Product Service Bulletin

ISSUE DATE: March 30th 2019
Bulletin Number: FB 2019-01
SUBJECT: Reserve pin ripcord assemblies on Firebird EVO Harness Containers
STATUS: **MANDATORY BEFORE NEXT JUMP**
Affected HC: All Firebird EVO HC with Pillow Ripcord assemblies PN 012 built between April 2018-March 2019, Serial numbers BD 001-CB 010
To: All Firebird Dealers and Customers

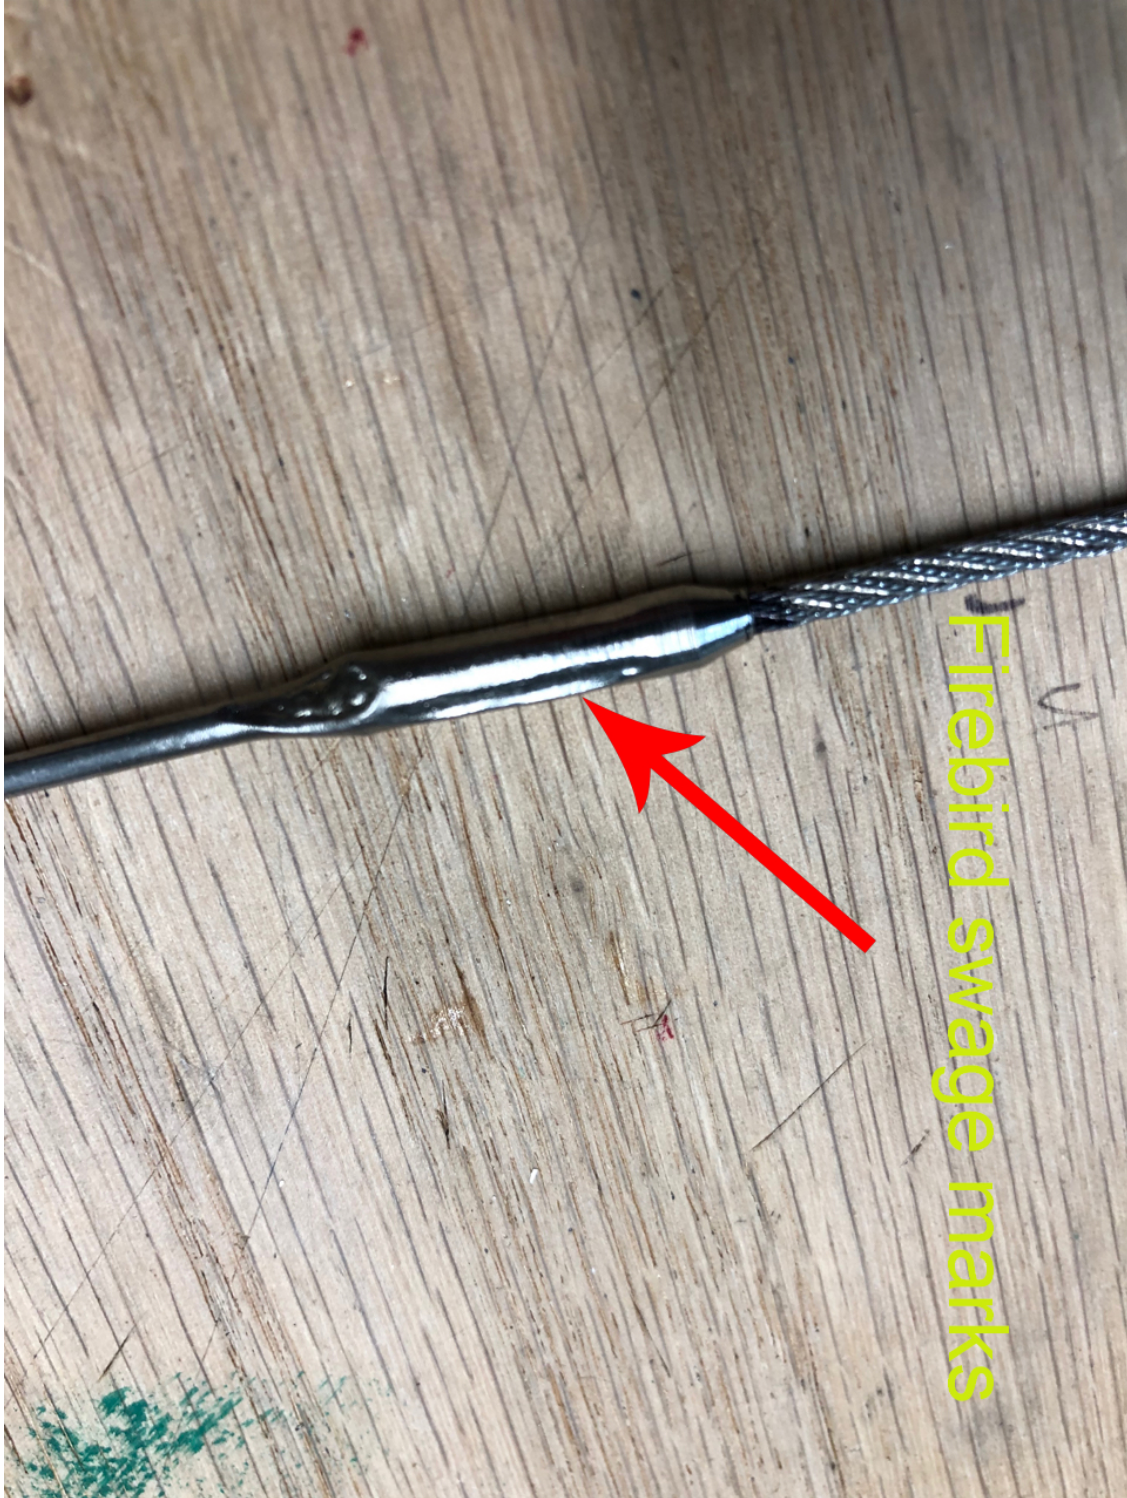
If your reserve pin doesn't have clear swage marks as pictured, DO NOT JUMP until notification and further inspection through Firebird USA LLC.

DO NOT JUMP

No swage marks

MANDATORY visually inspection of the pin cable junction by a FAA certified Senior or Master Rigger (or national equivalent) before next jump.

If your HC has a ripcord pillow ripcord assembly installed between SN BD001 and CB010 they have to be visually inspected for swaging marks.
